Parts Manual

Variable Displacement Motors Series 51, 80cc

Subject Threshold adjustment screw.

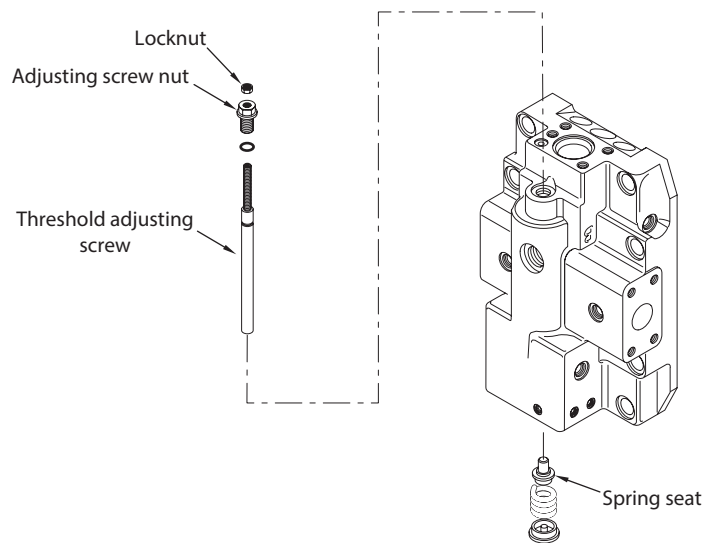
To improve the sensitivity of the threshold adjustment on Series 51 motors, the threads on the adjusting screw are being changed from standard pitch thread to fine pitch thread. The adjusting screw nut and lock nut will also change. At the same time, the bore diameter in the end of the adjusting screw and the pin diameter on the end of the spring seat will decrease.

Serial numbers This change became effective at serial number N-96-07-xxxxx.

Change to balanced areas between end cap and valve segment.

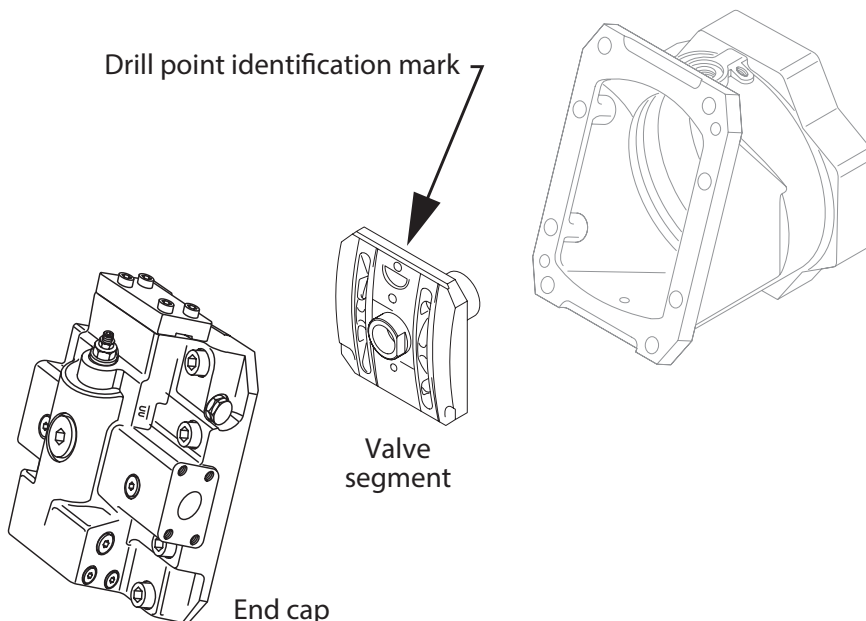
As part of the continuing Series 51 product improvement program, the balance lands on the end cap and valve segment have been changed. The valve segment now defines the balance. The contact surface of the end cap has been made larger while the contact surface of the valve segment has been reduced. The change was implemented in three steps:

1. Change the valve segment so it defines the balance between the valve segment and the end cap. This change was implemented May 1994.
2. Change the end cap to allow a larger contact surface to keep the load arwea constant. This change was implemented January 1995
3. Change the valve segment to allow a smaller contact surface and reduce the balance. This change was implemented Februrary 1996.

Service Bulletin: SB-1998-086

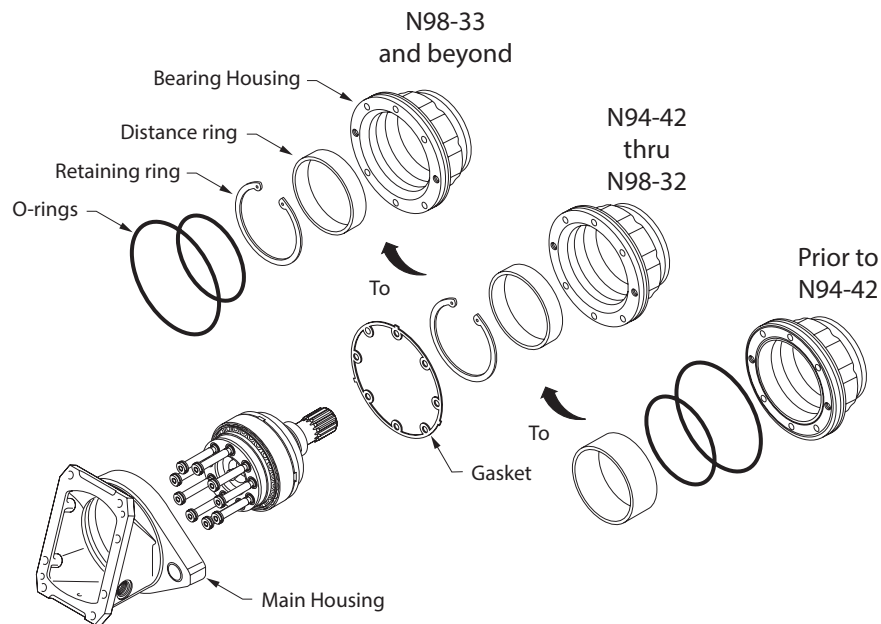
Subject Change from gasket to O-ring sealing at interface between housings.

Description As a joint sealing improvement, Sauer-Danfoss is changing the type of seal between the housings on Series 51 cartridge type motors in the 80cc frame size. With this change, two O-rings are incorporated into the design replacing the gasket. This design is similar, but with different size O-rings to the two O-ring design originally used on the 80cc cartridge motor, prior to the incorporation of the speed sensor option (see SB-1998-035). Both housings have been changed so they are not individually interchangeable with the "gasket" design housings. The "gasket" design housings and gasket part numbers will remain available as service parts.

Serial numbers Change became effective at serial number N-98-33-xxxxx

Thread change at customer end of DIN shaft assemblies.

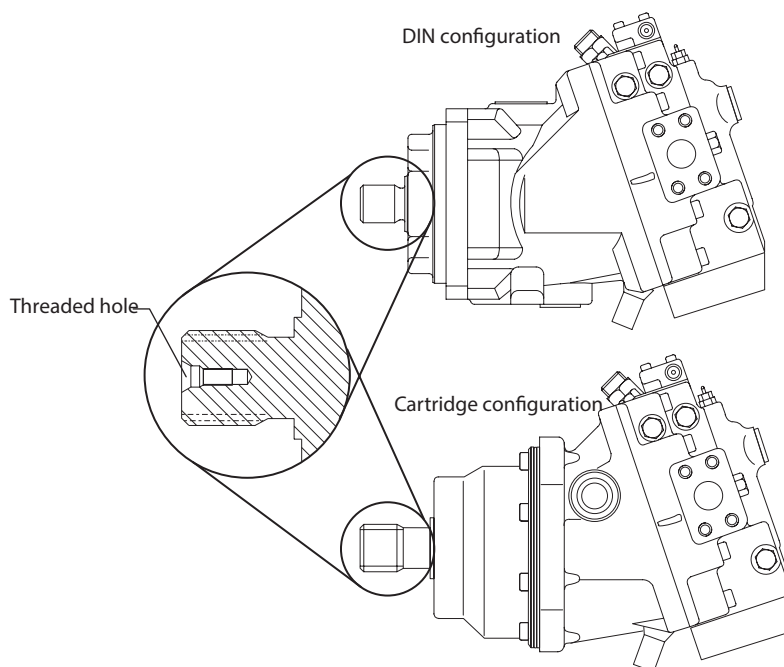
As a product improvement, Sauer-Danfoss has changed the threaded hole at the customer end of DIN shaft assemblies to metric threads. Metric shaft assemblies will now have a metric threaded hole. To aid in identifying this change, new shaft assembly part numbers have been released. The new shaft assemblies are interchangeable with the previous shaft assemblies. The previous shaft assembly part numbers will become obsolete.

Sealing change to end cap/control interface

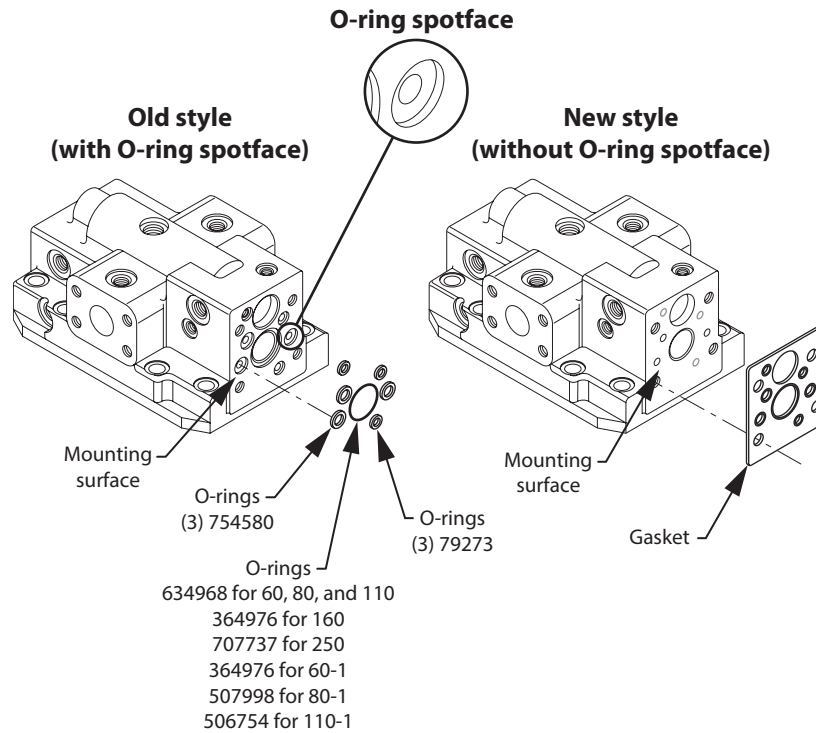
The sealing is improved between the end cap and controls or multi-function blocks on all Series 51 and 51-1 motors. This change replaces individual O-rings with a gasket that incorporates imbedded rubber seal rings. The O-ring spot faces are removed from the end cap mounting face. There is no change to controls' and multi-function blocks' sealing surface.

New end cap part numbers allow better control of this change. Old end cap part numbers are obsolete. You cannot use the new gasket with old end caps and you cannot use the O-rings with new end caps. Control and multi-function block kit now include the O-rings and the new gasket.

- Non-interchangeable;
- Order replacement parts

Service Bulletin: SB-2009-005

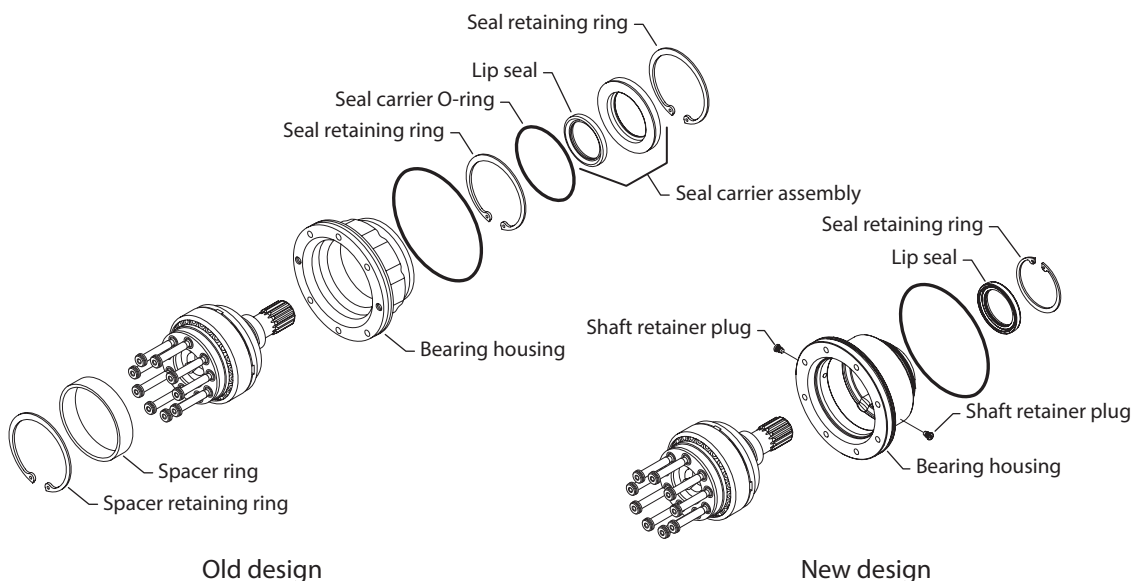
Description	Old part number	Replacement part number
Bearing housing	11009204	11038245
Spacer retaining ring	501120	11056747 (retainer plugs)(2)
Seal carrier assembly	510482	No longer used
Lip seal	519021	No Change
Seal retaining ring	392456 (2)	915280 (1)
Spacer ring	501116	No longer used
Seal carrier O-ring	501879	No longer used

- Non-interchangeable
- Use parts in stock for repair of units built before serial number N09-46-xxxxx
- Order replacement parts
- Revise existing part orders
